Re: Significant Corrective Action Permit Application
230 Ridgefield Road, Wilton, CT

Following comments received at the Wetland Commission's June 10, 2021 meeting, the following responses are provided.

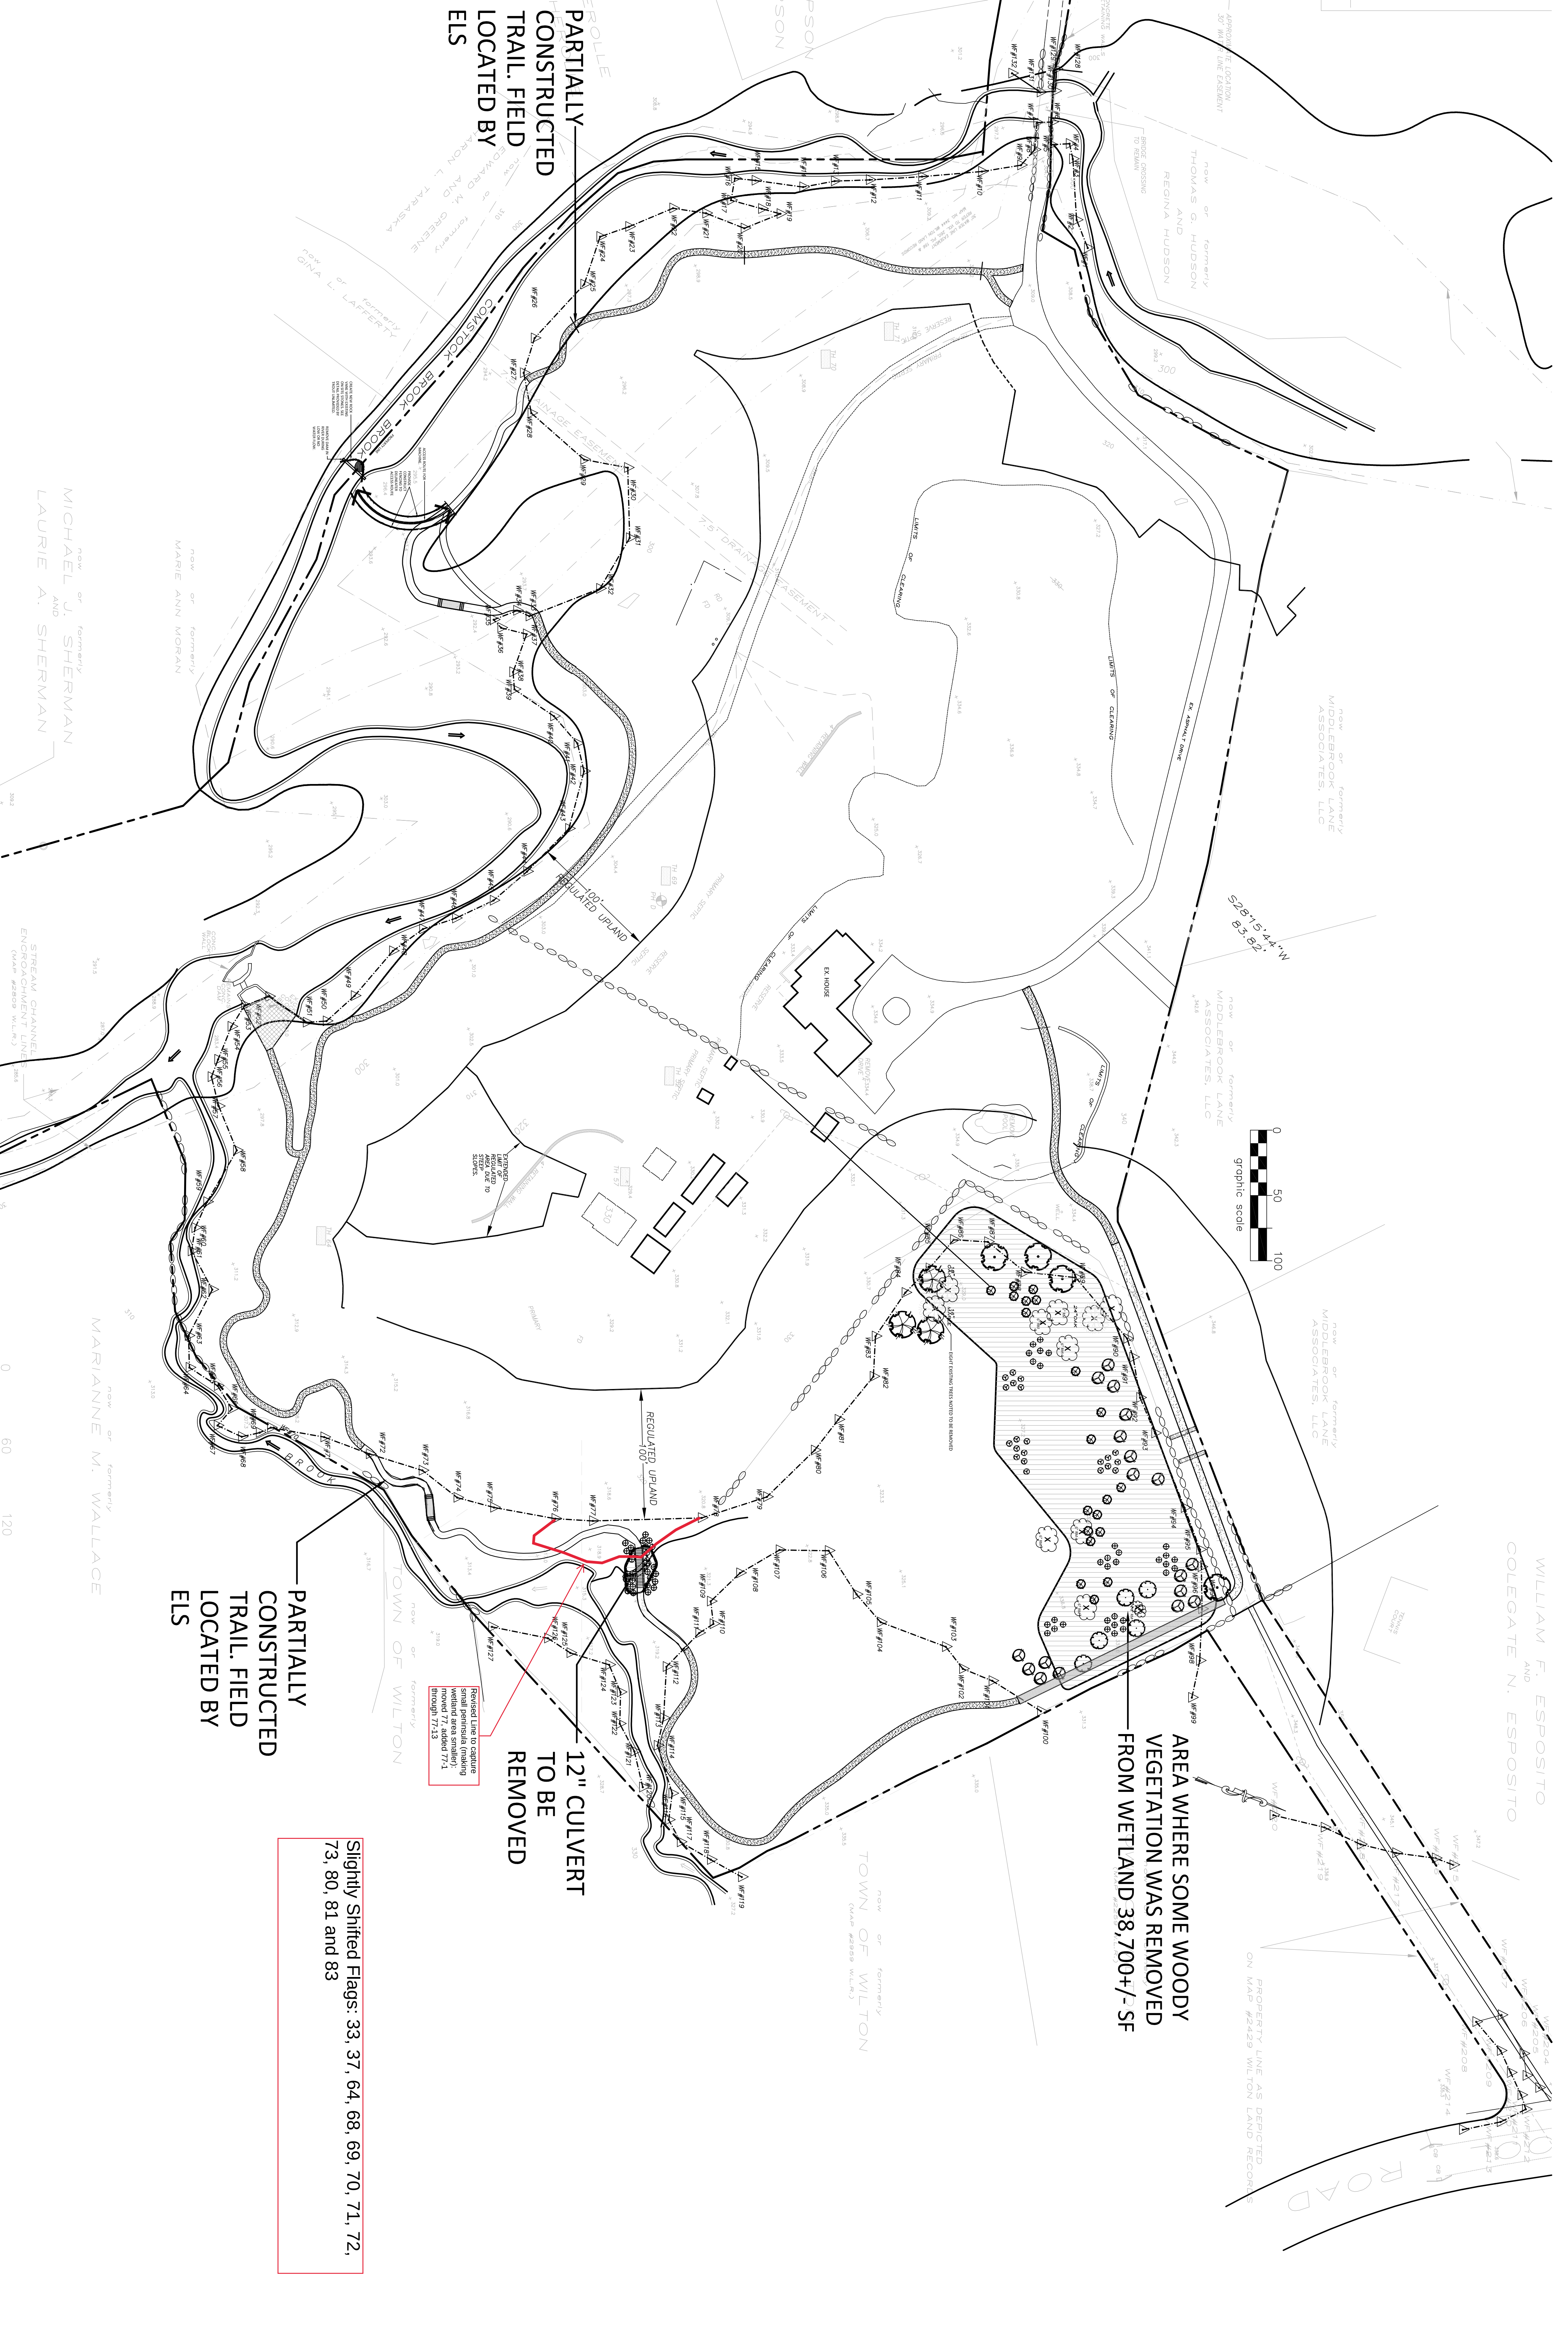
3. The staff raised a question regarding the wetland's line adjustment made by Eric Davidson. To help clarify this item I have resubmitted the wetland report with the wetland field sketch previously lacking, that provides the references adjustment in the wetland line. In addition, during the site walk on 6/21/21 the area was reviewed and I had a follow-up phone call with the staff. I believe we have addressed staff's concern. The survey has not been updated in part due to the backlog of surveying work, but the applicant is willing to do this as a part of final resolution.

Revised Line to capture
small peninsula (making
wetland 38,700+/- SF)
moved 77 added 77.1
through 77.13

Slightly Shifted Flags: 33, 37, 64, 68, 69, 70, 71, 72,
73, 80, 81 and 83
